Module stressed input loss calibration and other loss curves

P802.3ck D3.0 comments 202 216 218 223

Piers Dawe, Nvidia

February 2022

Figure 120G-11—Module stressed input target high-loss frequency-dependent attenuator differential-mode to differential-mode insertion loss

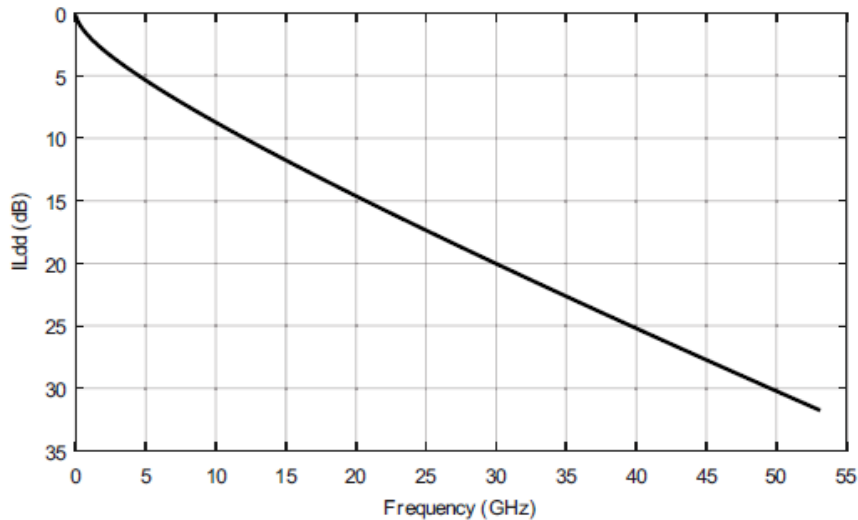
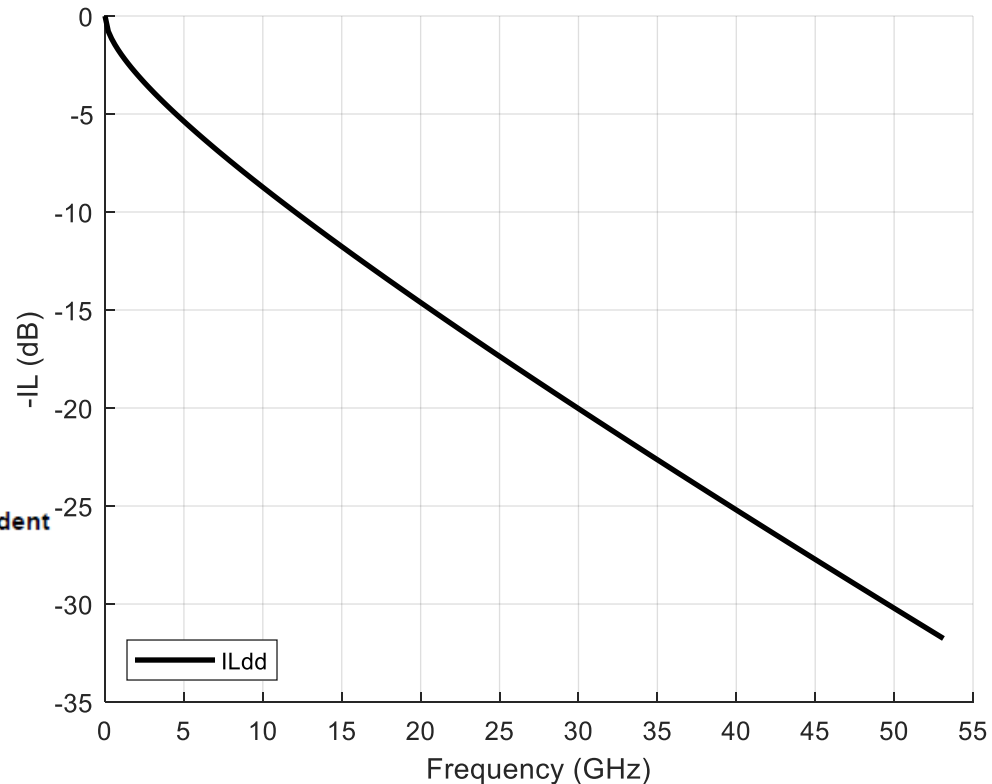
- 18.2 dB at Nyquist
- $IL_{dd}(f) = 1.54\sqrt{f} + 0.3865f$ (120G-3)
- In spite of the figure title, this is not the frequency-dependent attenuator alone

D3.0

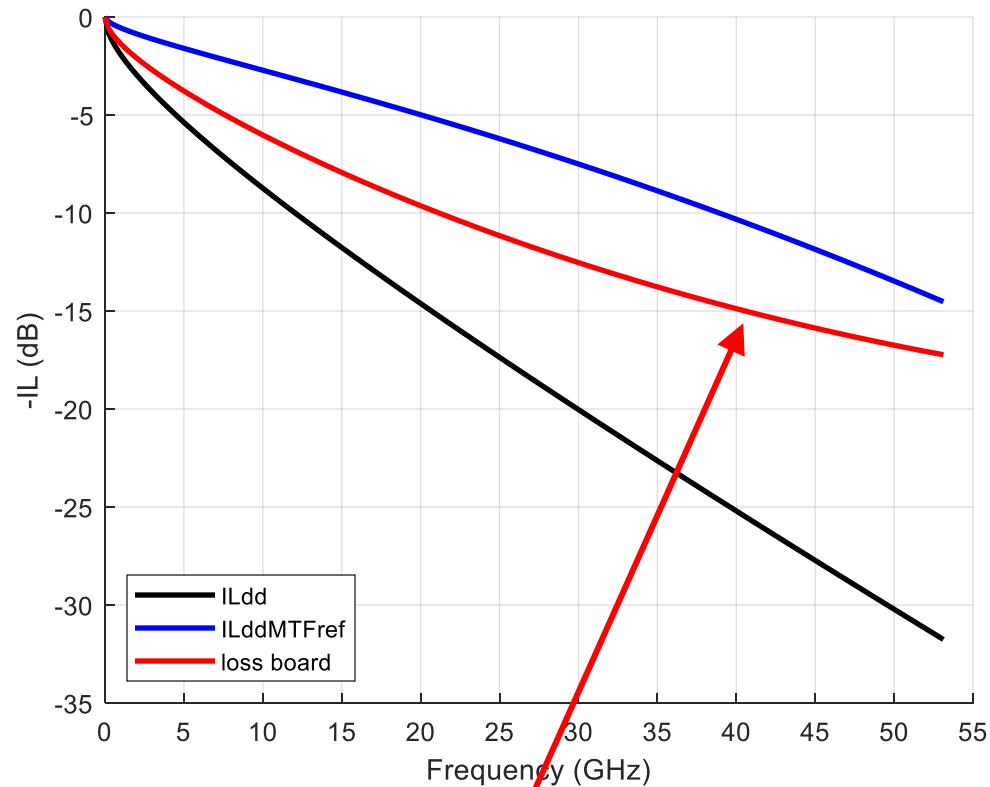
- The mated compliance boards target the blue line
 - $ILddMTFref(f) = 0.942(0.471\sqrt{f} + 0.1194f + 0.002 * f^2)$ Eq 162B–5
 - 6.6036 dB at Nyquist
- So the frequency-dependent attenuator must target the red line which bends too much the **wrong way** (f^2 term with wrong sign)
- Impractical, and not representative of the host-to-module channel and the channels used for module output compliance

November proposal

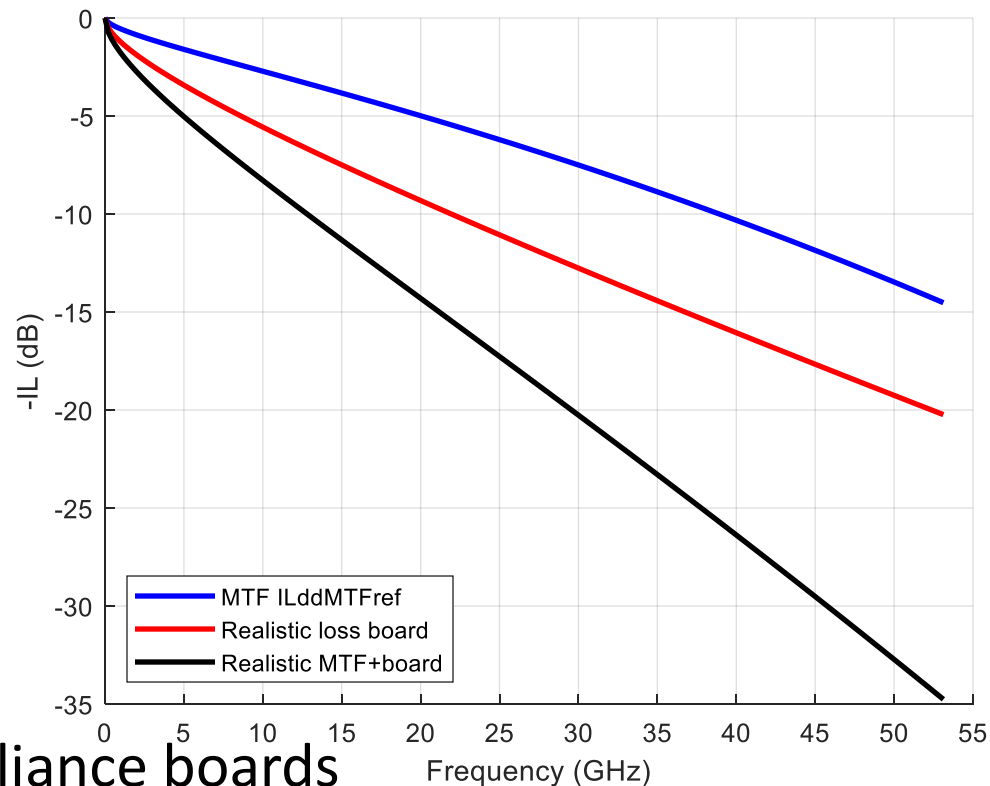
- Blue: mated compliance boards
 - $IL_{ddMTFref}(f) = 0.942(0.471\sqrt{f} + 0.1194f + 0.002*f^2)$ Eq 162B–5
 - 6.6036 dB at Nyquist
- Red: frequency-dependent attenuator
 - $0.980926\sqrt{f} + 0.246243f$ (Eq 120G-3 revised) 11.5964 dB at Nyquist
- Black: total
 - $1.42461\sqrt{f} + 0.358718f + 0.001884*f^2$ 18.2 dB at Nyquist
- More practical and representative of the host-to-module channel, **but...**

Comparing November proposal to D3.0

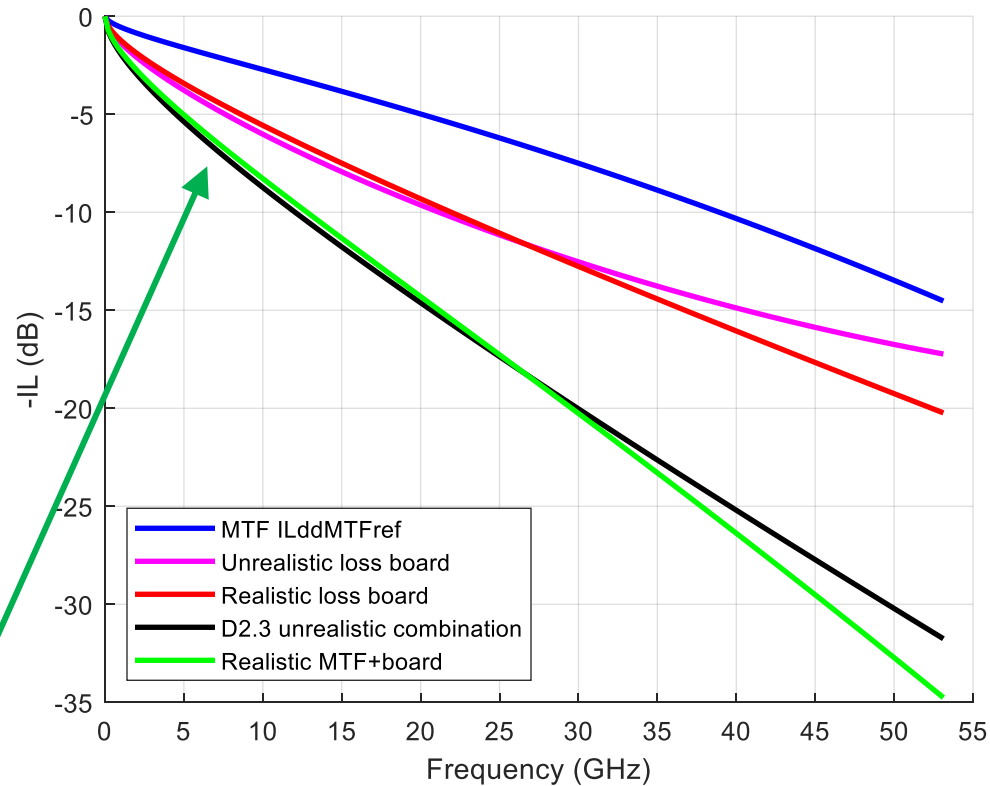
- Green line is better than black line, except not bowed enough at lower frequencies

Comment 218 Real compliance boards

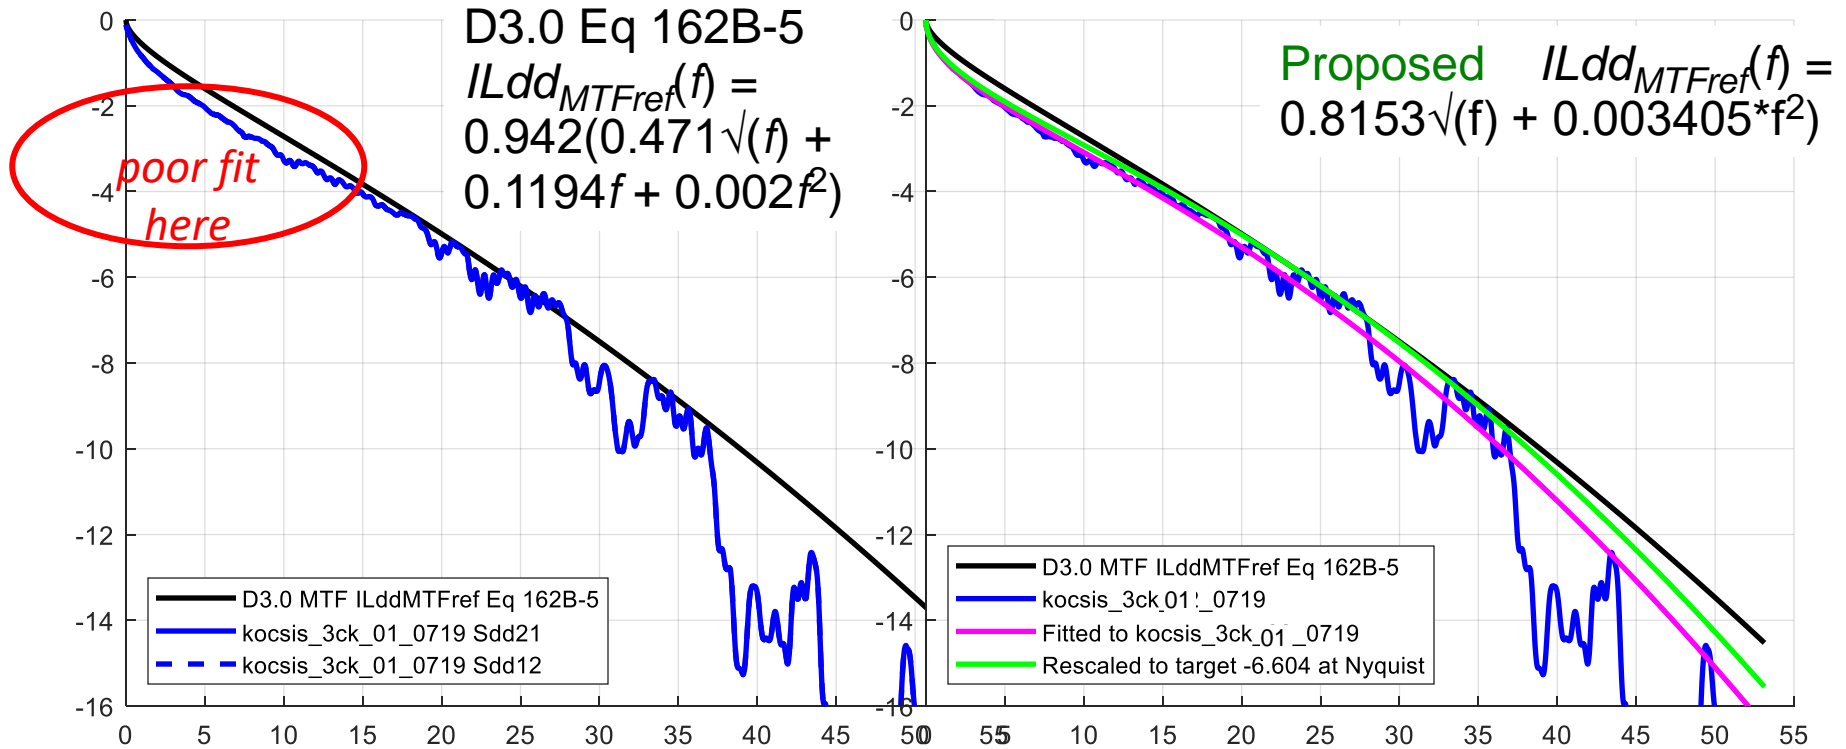
- We don't expect that compliance board traces will get shorter
 - Possibly the opposite as we go from 4 to 8 to maybe 16-wide modules
- But they might use better dielectric, and tolerancing and detailed improvements
- So the low frequency loss will improve less than the high frequency loss

Comment 218 on compliance boards, summary

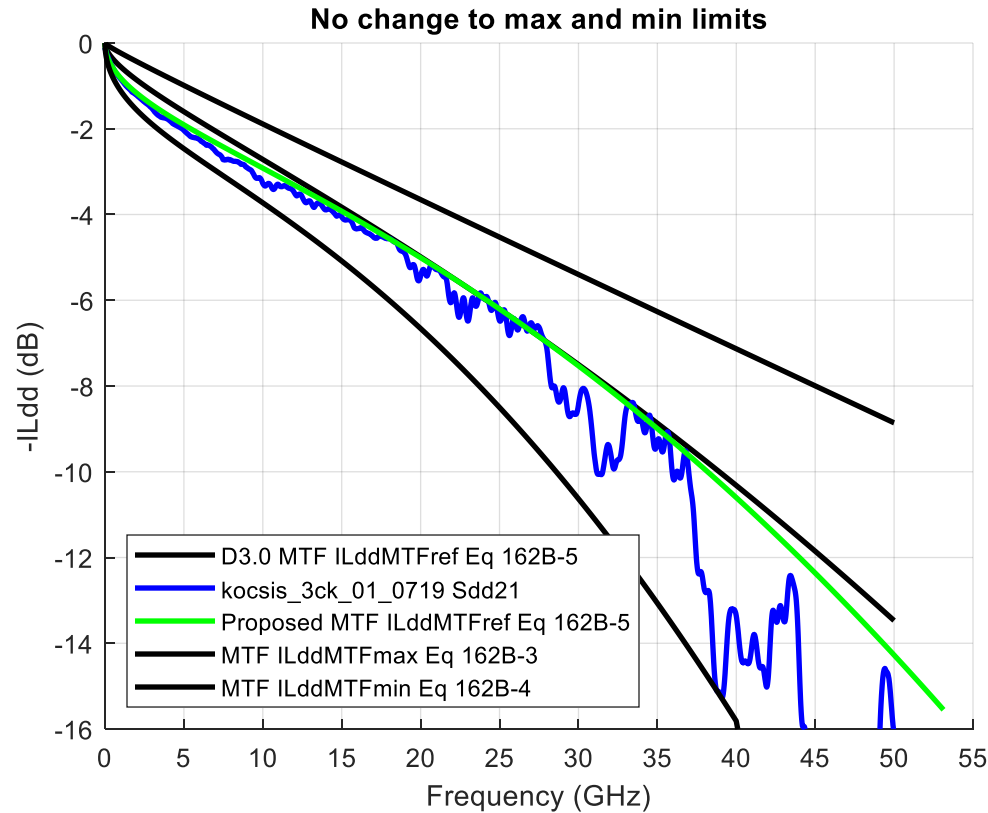
- Change equation 162B-5 from:
- $ILdd_{MTFref}(f) = 0.942(0.471v(f) + 0.1194f + 0.002f^2)$ to:
- $ILdd_{MTFref}(f) = 0.8153v(f) + 0.003405f^2$
- Update Figure 162B-3, Mated test fixtures differential-mode to differential-mode insertion loss

New curves for Figure 120G-11

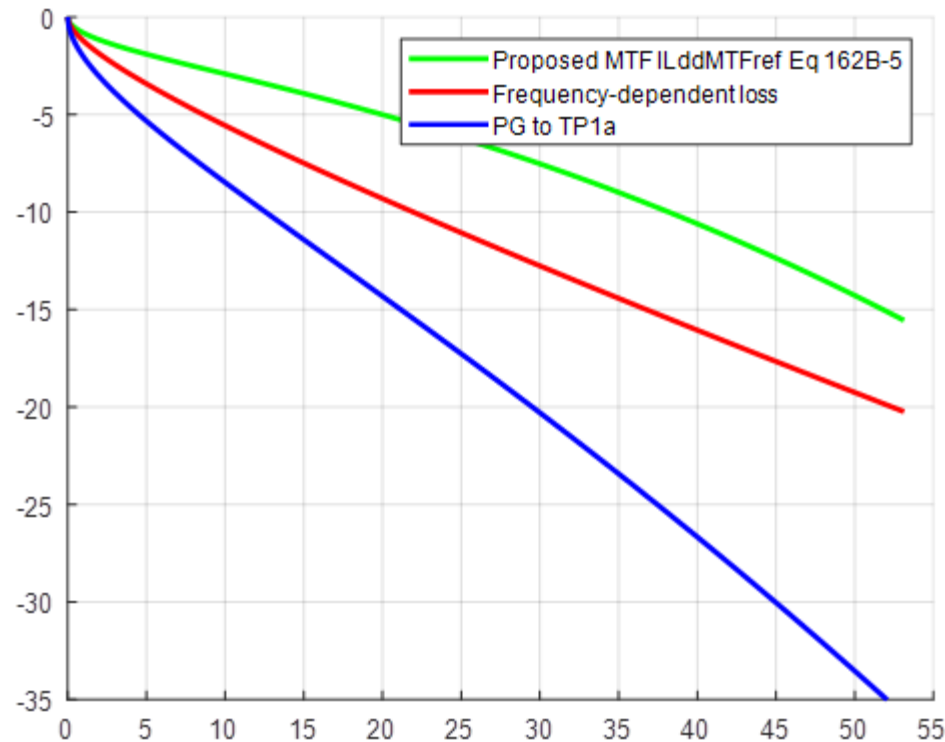
- Comment 202: Show all three curves (Eq 162B-5 mated compliance boards, frequency-dependent attenuator and the combination) in Figure 120G-11
- This plot is based on the compliance board curve accepted in comment 218 (shown green and called "proposed" here)
- It shows three of the lines on slide 7

Figure 163B-1—Example test fixture differential-mode to differential-mode insertion loss

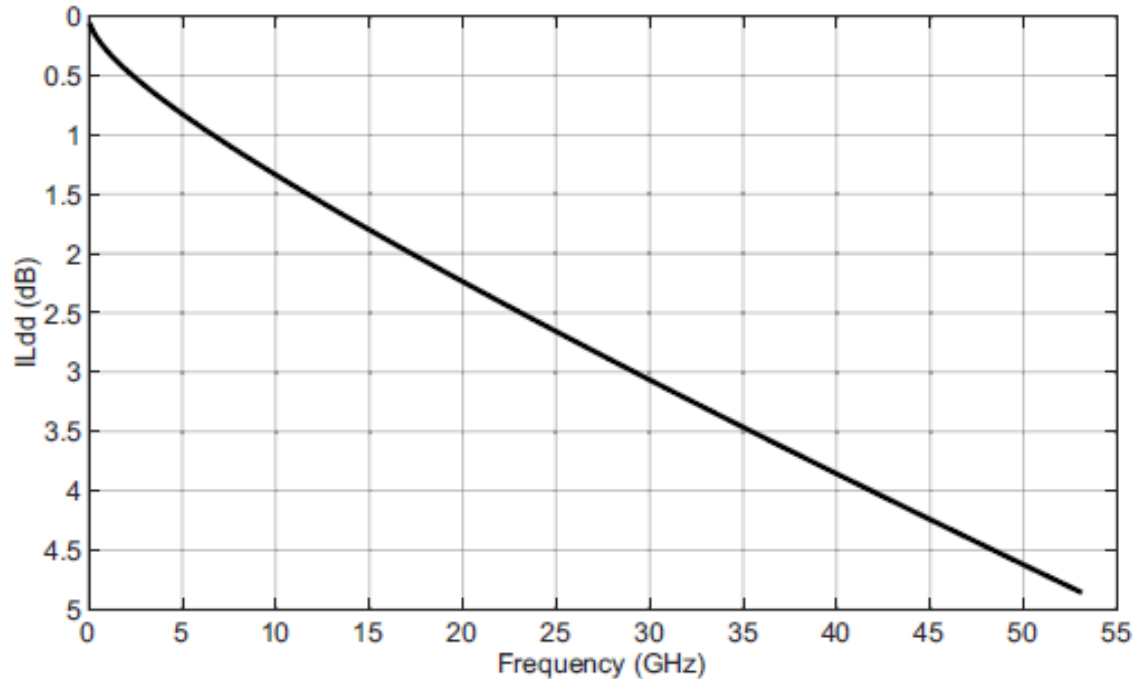
Figure 163B-1 doesn't match Equation 163B-1

- D3.0 Eq 163B-1 $Il_{dd}(f) = 0.074 + 0.2104\sqrt{f} + 0.0674f$ $0.05 \leq f \leq 53.125$
- I believe the graph is right, and the right coefficients are 0, 0.235616, 0.059147
- Change to: $Il_{dd}(f) = 0.235616\sqrt{f} + 0.059147f$ $0.05 \leq f \leq 53.125$
